Access Compliance Report

Public Rights-of-Way

Intersection ID: 5879	Main Street: NEVIN_RD	Cross Street: ZION_RENAISSANCE_LN	Location: NW
ADA ID: A73A30ED1273	Ramp Type: MedianPerp	Initial Pass/Fail: Fail	Overall Compliance: No
		Severity Score: 12.5

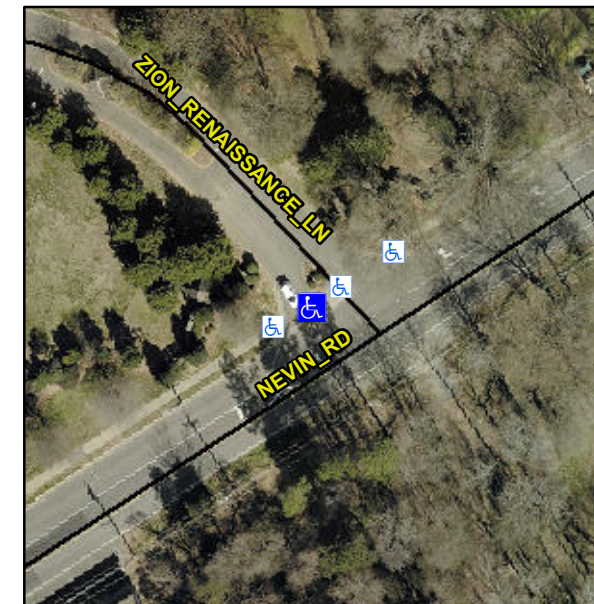
Not Found, R304.2.2

Compliance	Description	Data	Compliance	Description	Data
N/A	Ramp Length (in)	48.0	No	Ramp Slope (%)	11.4
Yes	Ramp Width (in)	68.0	Yes	Ramp XSlope (%)	1.5
N/A	Flare Type LT	N/A	N/A	Flare Type RT	N/A
N/A	Flare Slope LT (%)	N/A	N/A	Flare Slope RT (%)	N/A
N/A	Flare Traversable LT?	N/A	N/A	Flare Traversable RT?	N/A
N/A	Landing Length (in)	N/A	N/A	DWS Provided?	N/A
N/A	Landing Width (in)	N/A	N/A	DWS Contrast?	N/A
N/A	Landing Slope (%)	N/A	N/A	DWS Length (in)	N/A
N/A	Landing X Slope (%)	N/A	N/A	DWS Full Width?	N/A
N/A	Landing Curb? (Y/N)	N/A	N/A	DWS Offset (in)	N/A
N/A	Shared Landing?	N/A			
N/A	Gutter Ponding?	N/A	N/A	Gutter Slope (%)	N/A
N/A	Gutter Lip Ht (in)	N/A	N/A	Gutter X Slope (%)	N/A
N/A	Painted X Walk1?	No	N/A	Painted X Walk2?	N/A
	X Walk 1 Direction	To SW		X Walk 2 Direction	N/A
N/A	X Walk 1 Width (in)	N/A	N/A	X Walk 2 Width (in)	N/A
	X Walk 1 Slope (%)	2.5		X Walk 2 Slope (%)	N/A
	X Walk 1 X Slope (%)	0.1		X Walk 2 X Slope (%)	N/A

Remove & Replace Entire Ramp.
